Subject: NACA Inlet Ram Air Flapper Door Bonding Strap Replacement
Aircraft: Eclipse 500 and 550
Effectivity: Aircraft S/N 1 and Up
Applicability: Post SB 500-99-004

MEMO No. SEM-500-00189 Rev A

SUBJECT: NACA Inlet Ram Air Flapper Door Bonding Strap Replacement

Figure 1

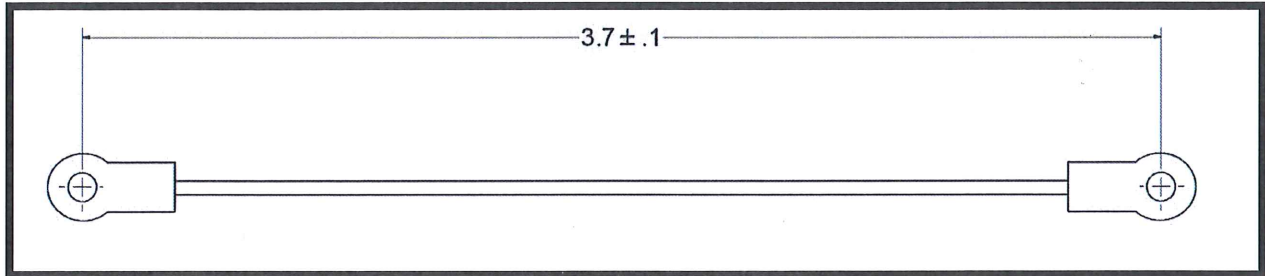
1. Replacement bonding straps may be fabricated from the following parts.
 - a) Alpha Tinned Copper Flat Braid Part No. 1223 or equivalent 22 AWG Tin Plated Copper Flat Braided Cable.
 - b) Panduit Non-Insulated Ring Tongue P/N P22-2R-C.

- c) Aerospace Standard Uninsulated Ring Tongue per MS20659-167.
2. The finished length of the bonding strap after assembly shall be $3.7 \pm .1$ inches from center to center of the ring tongue holes. (refer to figure 1 on page 2)
3. The ring tongues shall be crimped per manufacturer's instructions.

Figure 2

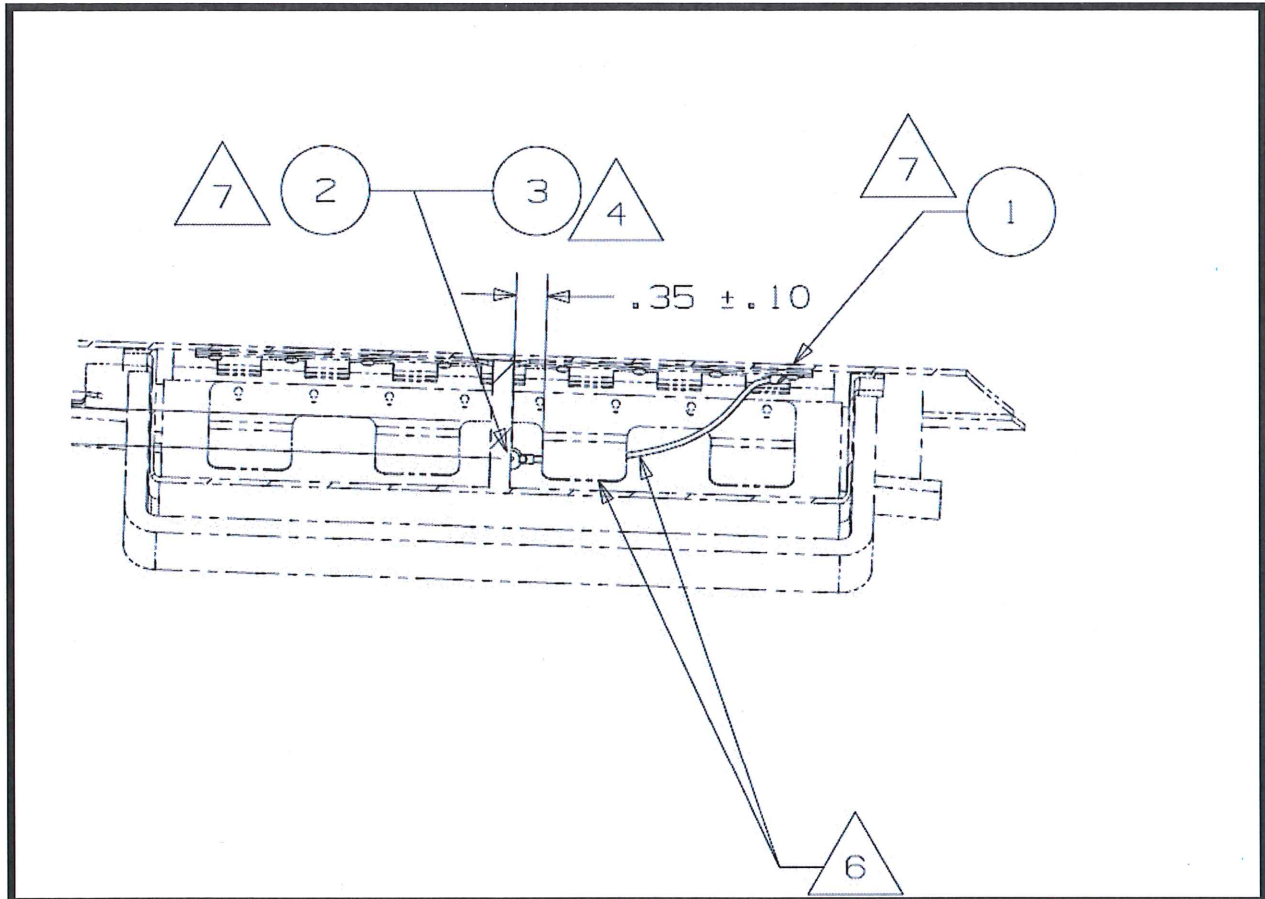
3. Bonding strap installation. (refer to figure 2 on page 2)

1. Attach bonding strap to NACA inlet using MS20426AD3-3 or NAS1097AD3-3 rivet.
2. Attach bonding strap to RAFD using MS20470AD3-3 rivet.
3. It is permissible to replace the MS20470AD3-3 rivet with an MS35206-213 pan head screw, 2 NAS11149DN416J flat washers, and an MS21042L04 self locking nut. If the rivet is replaced with a screw the fastener hole should be increased to 0.125 and a P22-4R-C or MS20659-138 ring tongue should be installed on the RAFD end of the bonding strap.
4. The RAFD must swing freely after bonding strap installation.
5. Resistance when measured with an ohm meter, shall not exceed 1.0 ohms when measured between the RAFD and the astrostrike layer in NACA inlet composite panel.
6. Bonding strap to route between divider plate and flapper plate as shown.
7. It is permissible to go up or down two rivet or screw grip lengths.
